Private Fuel Storage, L.L.C.

July 20, 2001

**MAP CORRECTION: JULY 18, 2001 SUBMITTAL**  
**DOCKET NO. 72-22 / TAC NO. L22462**  
**PRIVATE FUEL STORAGE FACILITY**  
**PRIVATE FUEL STORAGE L.L.C.**

...civil\0599602\site\gopher.dgn Jul. 02, 2001 12:41:54

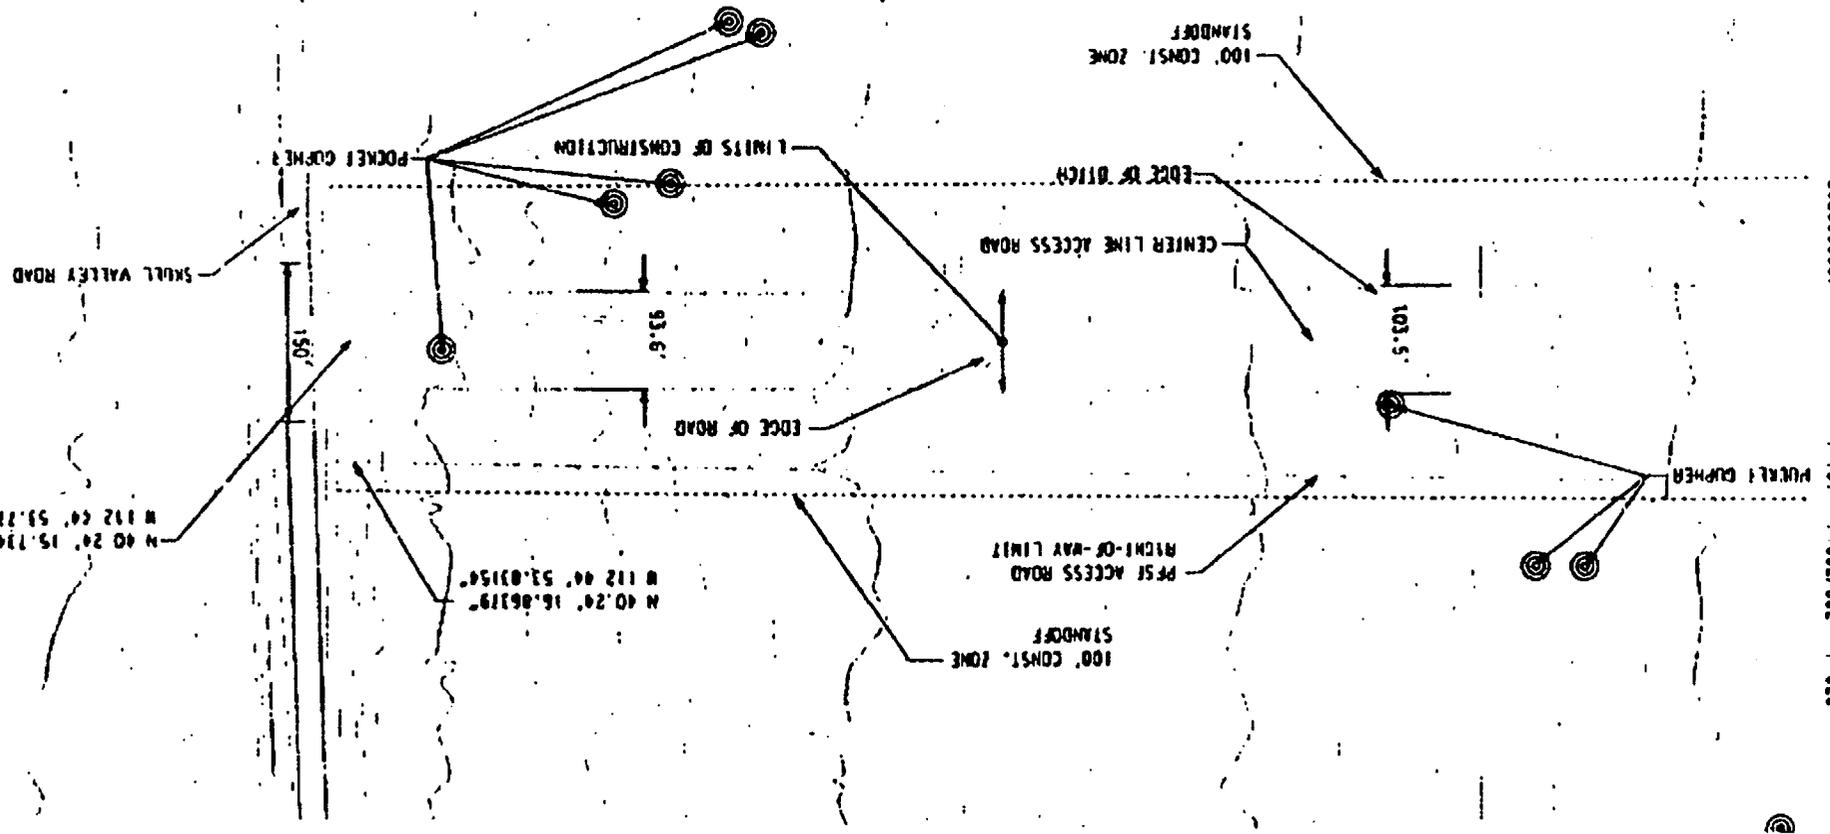
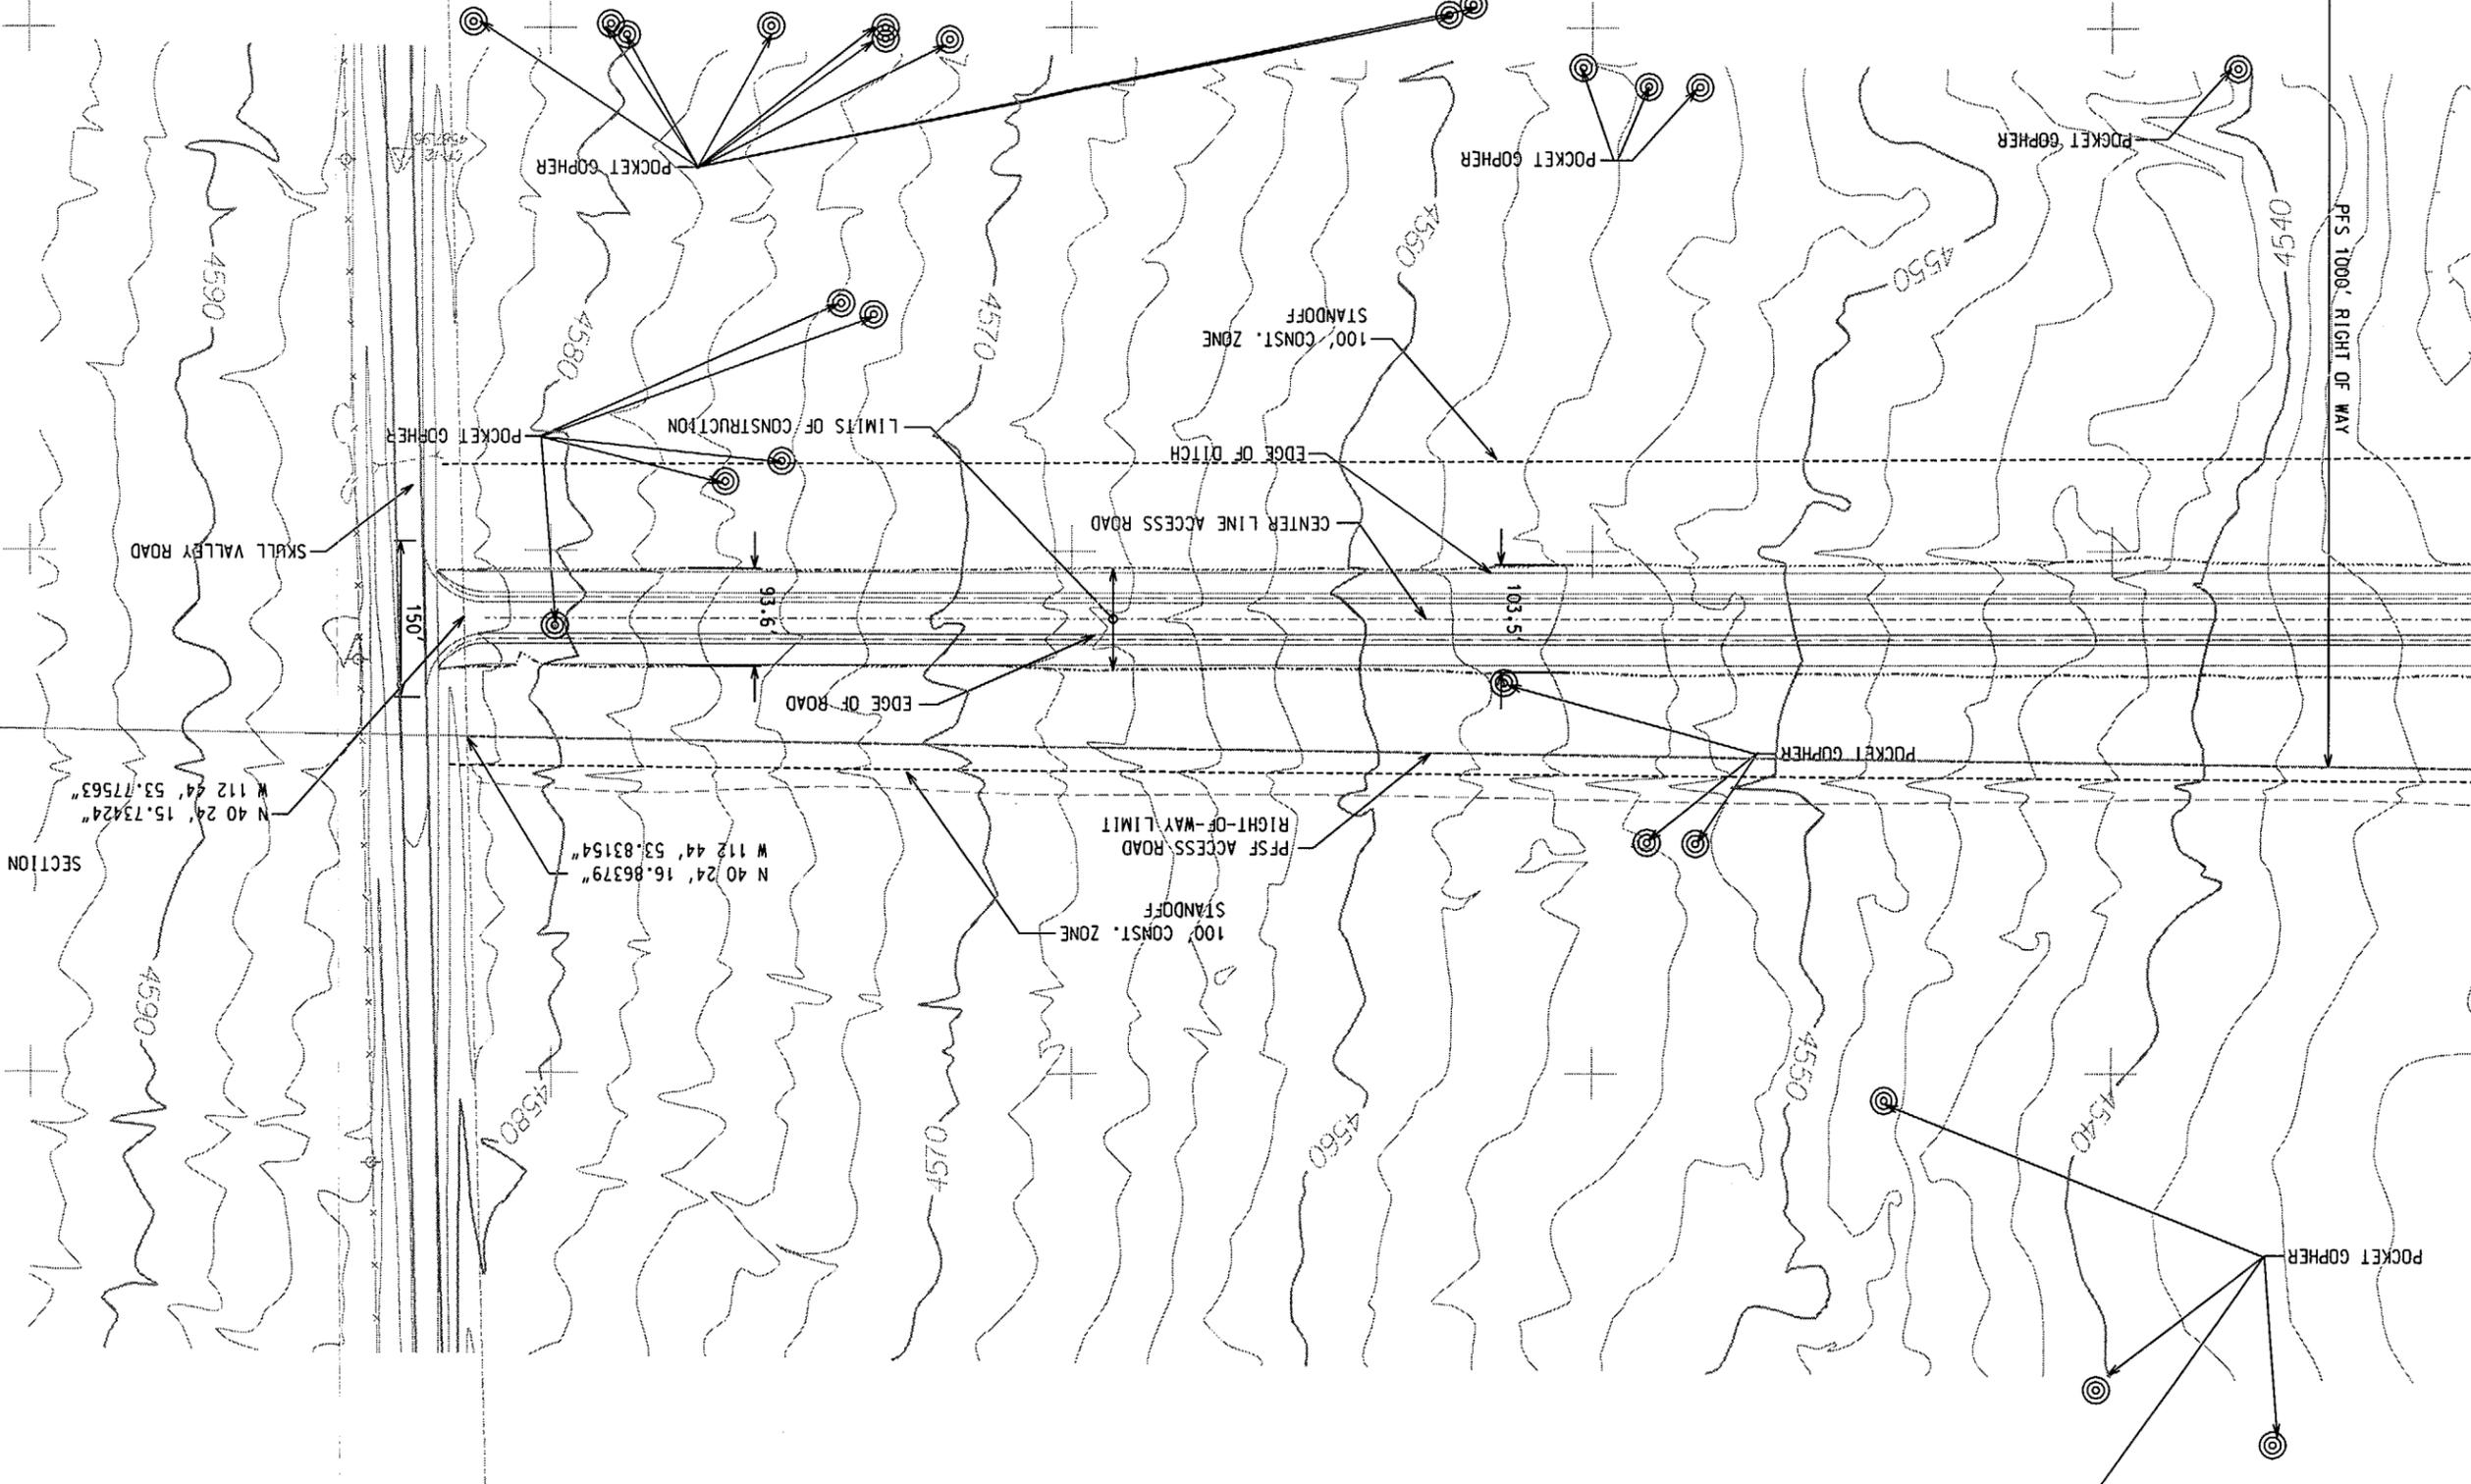
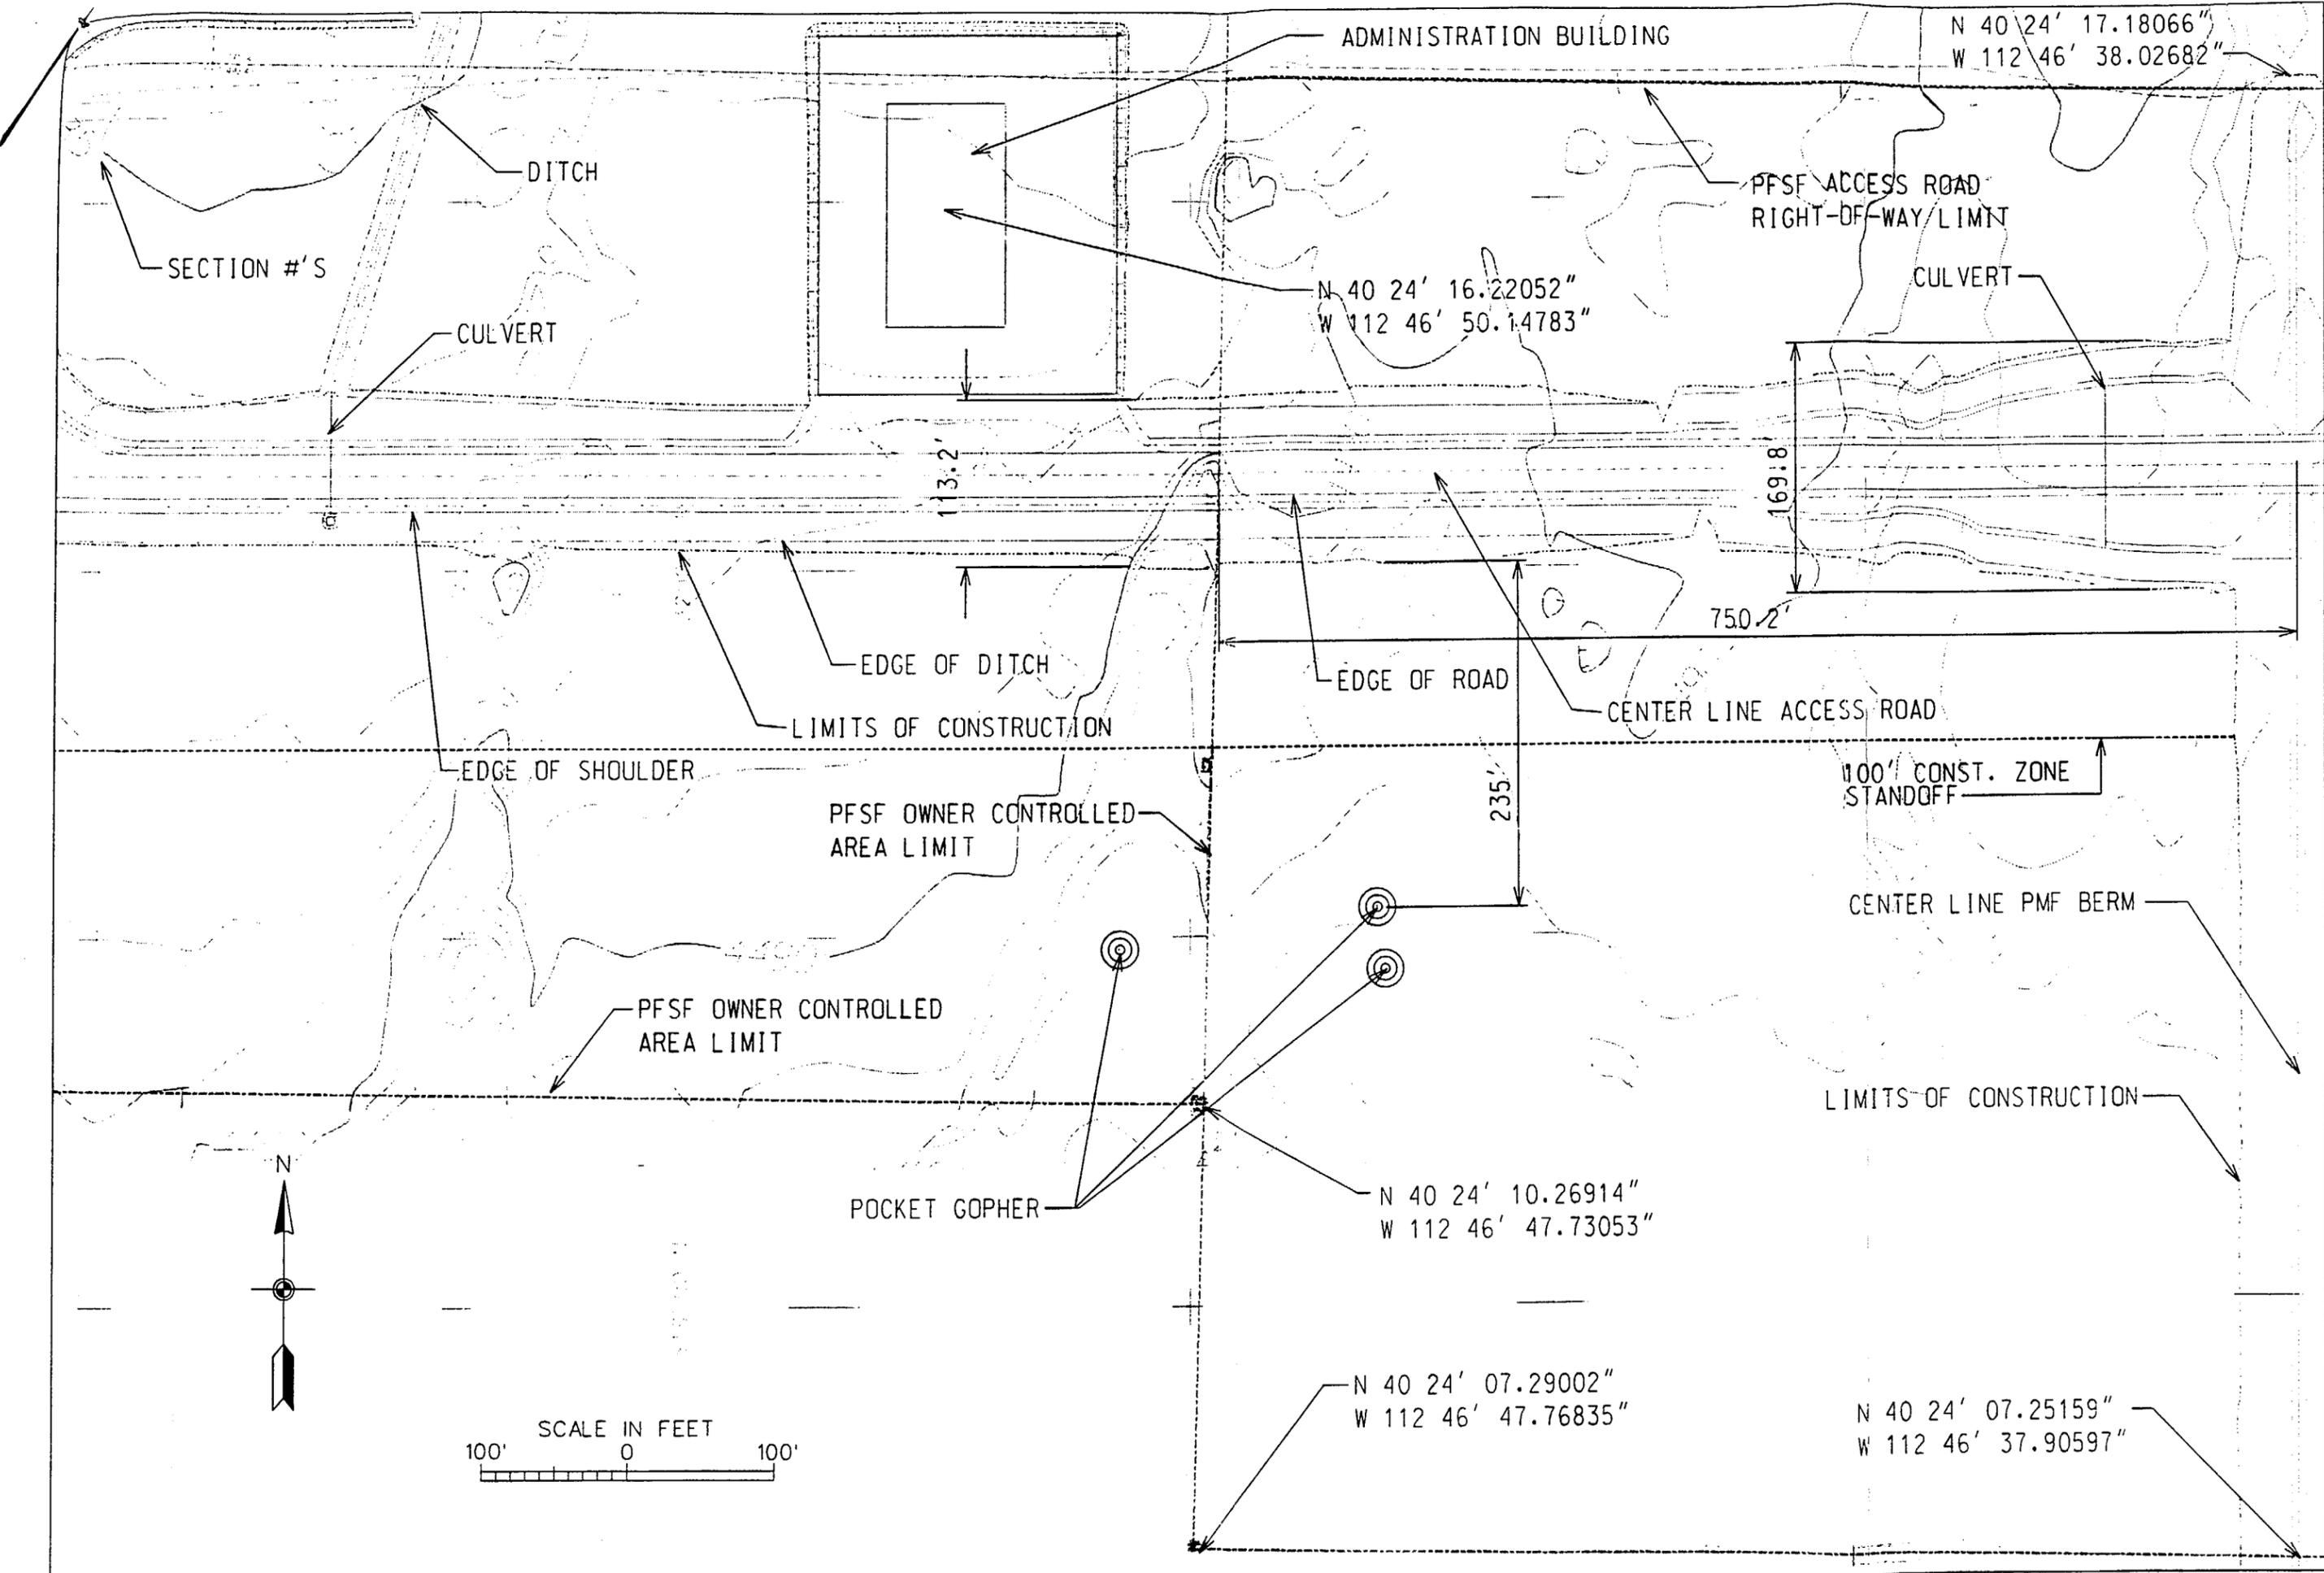
Attached with this letter is a corrected map showing the following three data points at their proper location. The three points remain outside of the construction zone. The PFS Environmental Report will be updated in the future to include the relevant reference material supplied to the NRC as discussed with Mr. M. Delligatti - NRC on July 19, 2001.

<u>Pritchett - Original</u>				<u>Corrected</u>			
N	40	24	09.1	N	40	24	10.5
W	112	44	16.0	W	112	45	09.0
N	40	24	10.9	N	40	24	10.6
W	112	44	01.9	W	112	45	08.4
N	40	24	11.1	N	40	24	10.4
W	112	44	26.0	W	112	45	07.6

*Typo in Lat/Long DATA*

*New  
lines  
added*
